**TOWN OF NEWBURGH  
PLANNING BOARD  
TECHNICAL REVIEW COMMENTS**

**PROJECT: MCDONALDS ROUTE 32-NORTH PLANK ROAD**  
**PROJECT NO.: 17-26**  
**PROJECT LOCATION: SECTION 76, BLOCK 1, LOT 1.1**  
**REVIEW DATE: 9 MARCH 2018**  
**MEETING DATE: 15 MARCH 2018**  
**PROJECT REPRESENTATIVE: HARRIS BEACH/BOHLER ENGINEERING- WARREN NJ**

**Re: McDonald's Restaurant/31-0145/01712  
65 North Plank Road (Route 32)  
Block 1, Lot 1.1., Section 76  
Town of Newburgh  
Orange County, New York (the "Property")  
Planning Board Project No. 2017-26**

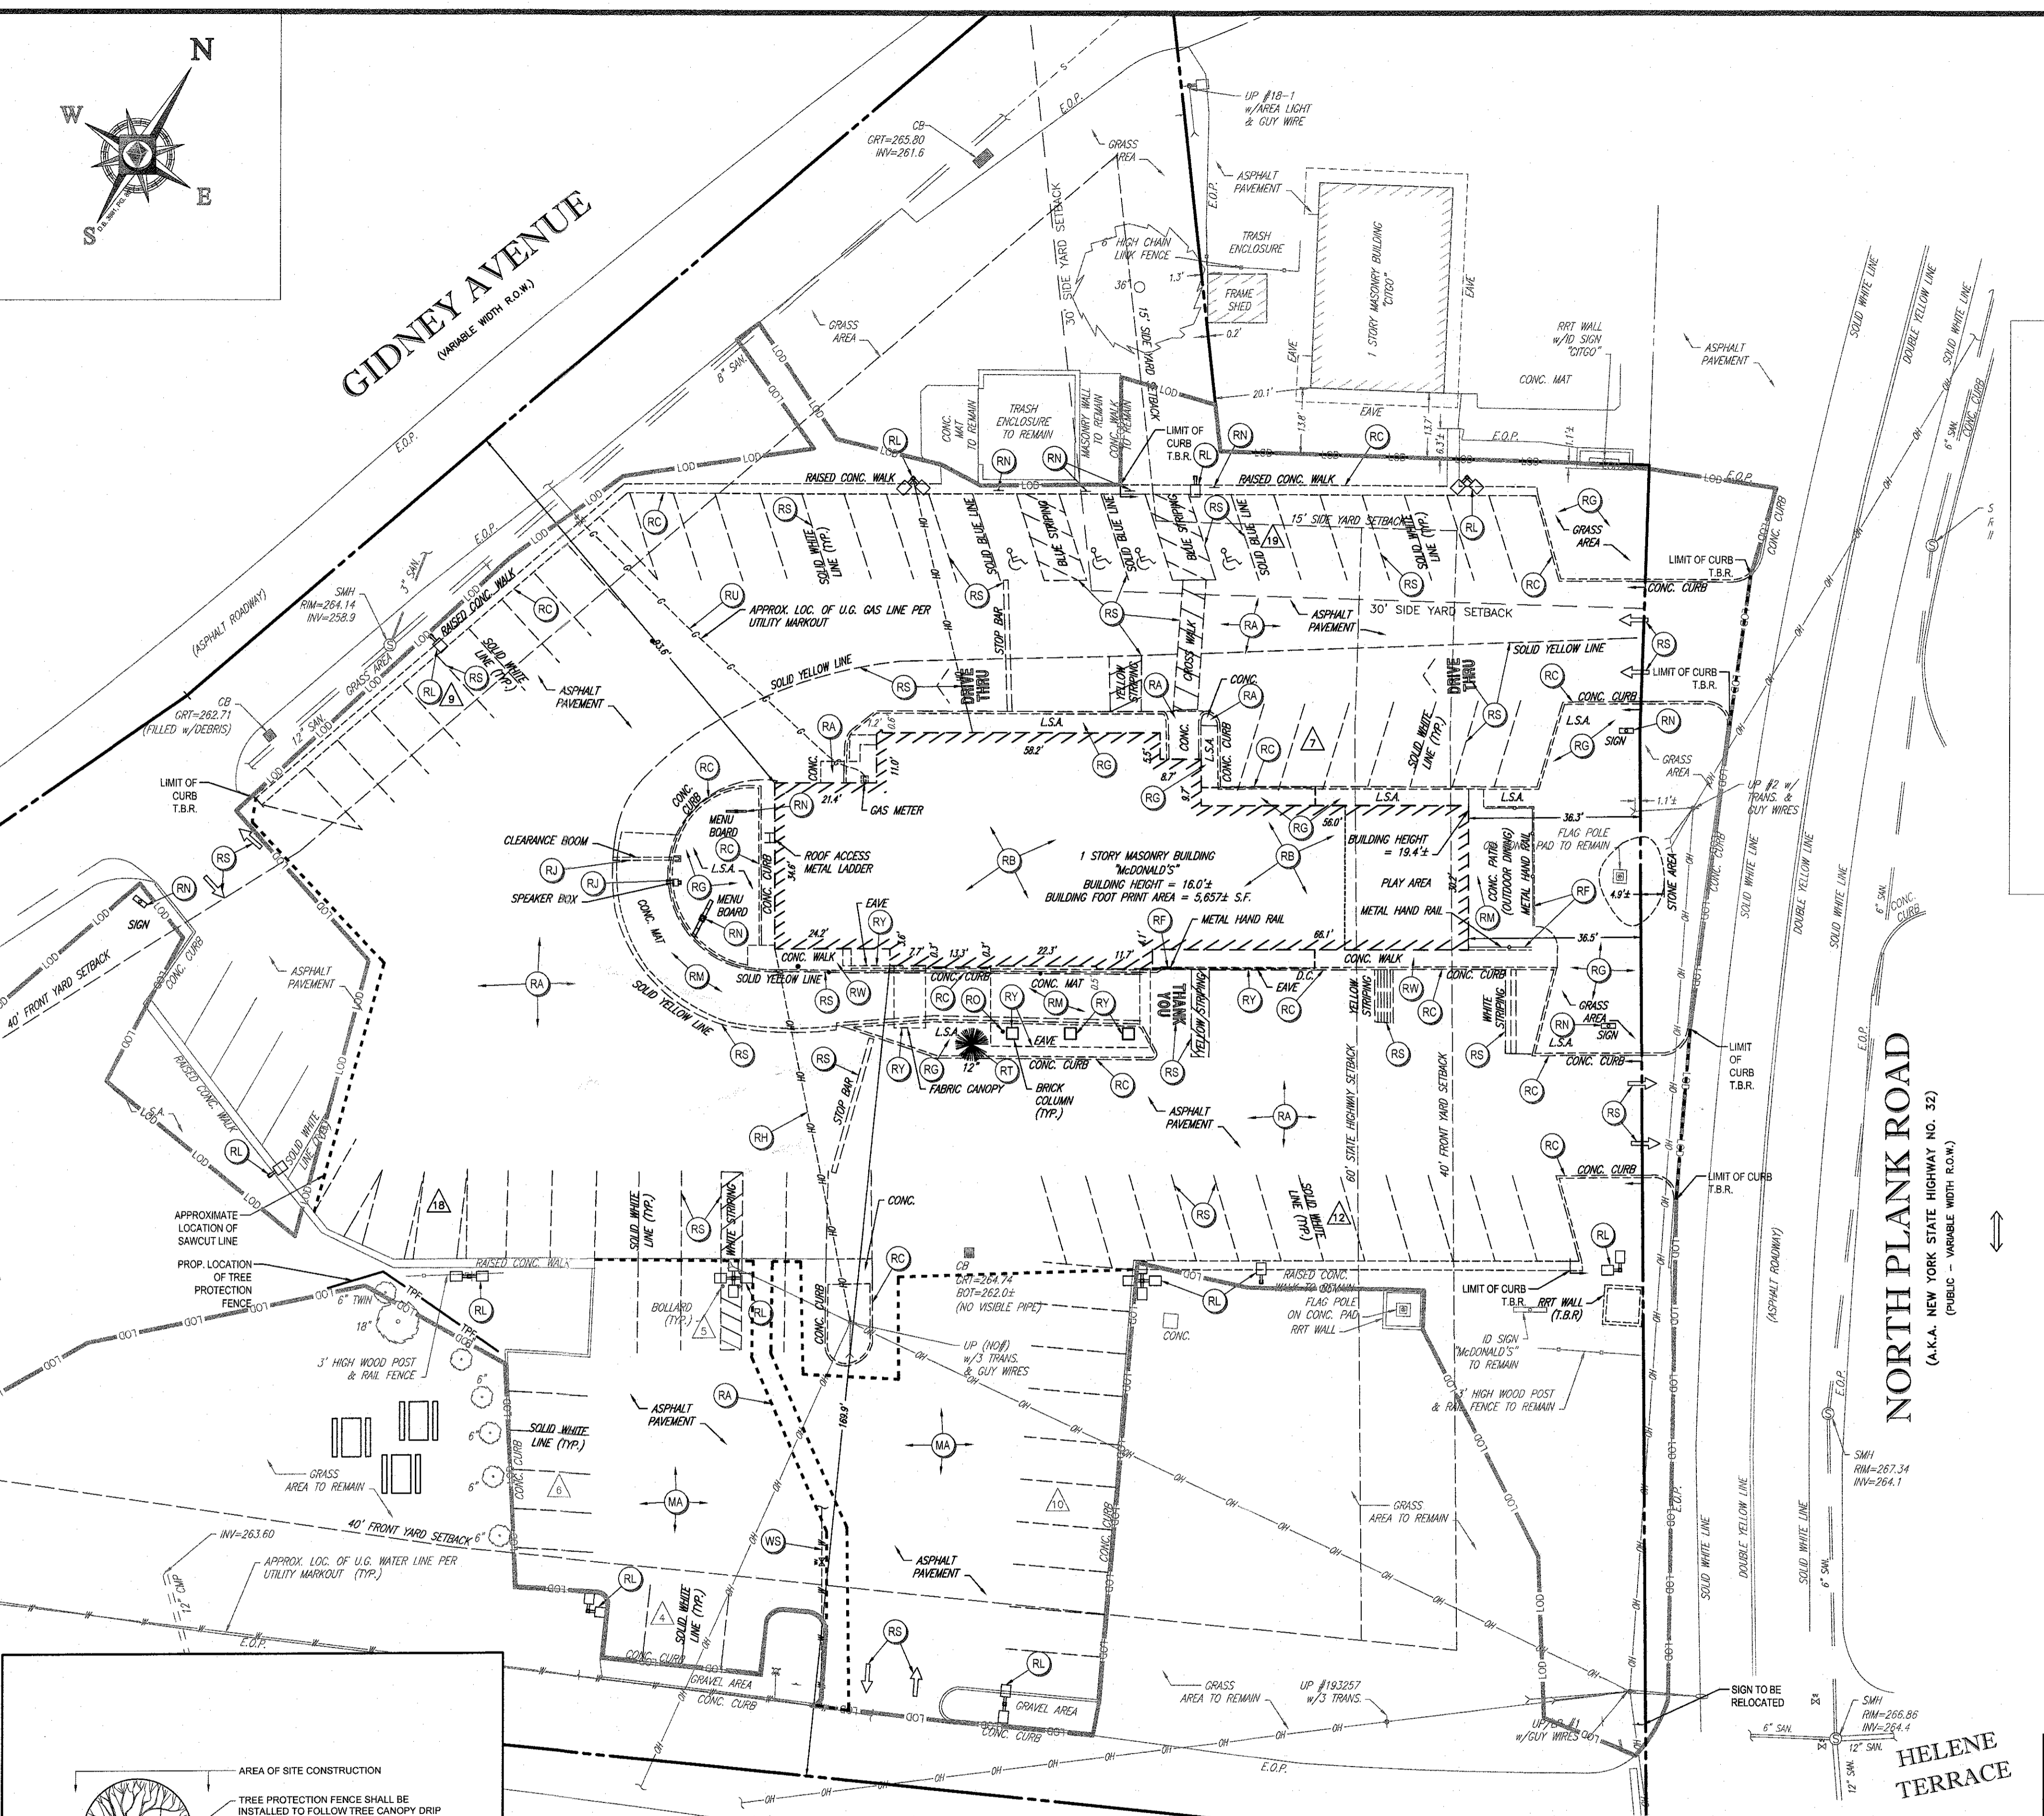
1. Addition of a reference to the requirements for a demolition permit on Sheet C-3.
2. Edits to the approval block on sheet C-1 to include only a line for the Planning Board Chairman's signature.
